STAFF REPORT: JULY 12, 2022 REGULAR MEETING

APPLICATION NUMBER: 23-8439

ADDRESS: 14910 STAHELIN

SCOPE: REMOVE WOOD PATIO DOOR, INSTALL VINYL PATIO DOOR

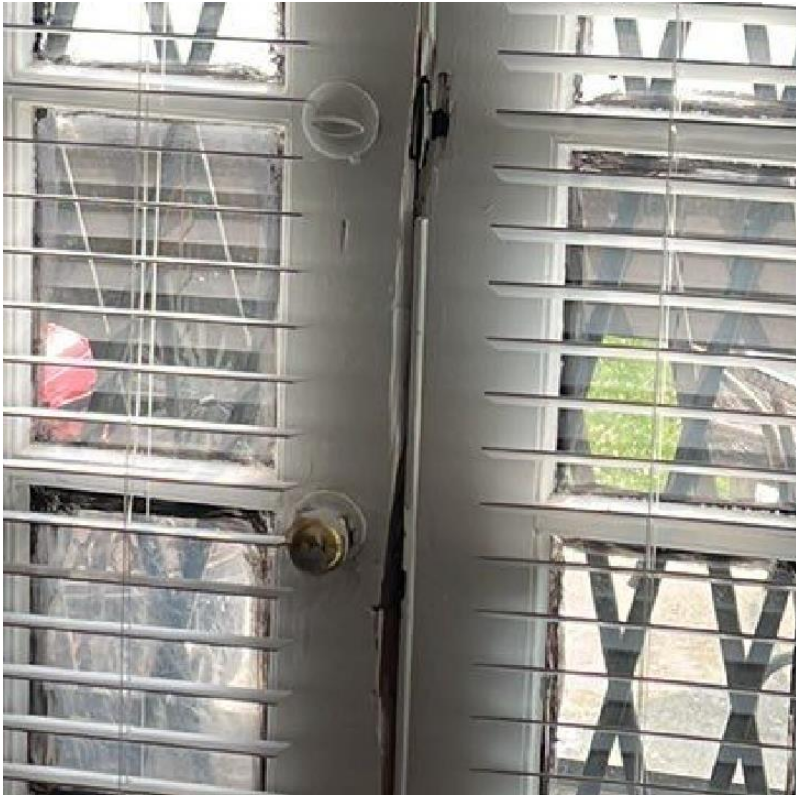
Doors are mentioned only in reference to arched door openings (which this door does not have) as being “characteristic.” However, staff suggests that the observations made in the Elements of Design with respect to windows apply with equal validity to doors. The subdivisions of the door create textural interest as described in the Elements of Design.

- The design of the existing exterior patio doors, with wider rails separating multilight windows, is consistent with the muntin-and-mullion character of the building's windows. On the proposed doors, grids would mimic the divided-light nature of the current doors. The proposed color, black, matches the existing door and historic windows and is appropriate for Tudor Revival architecture.
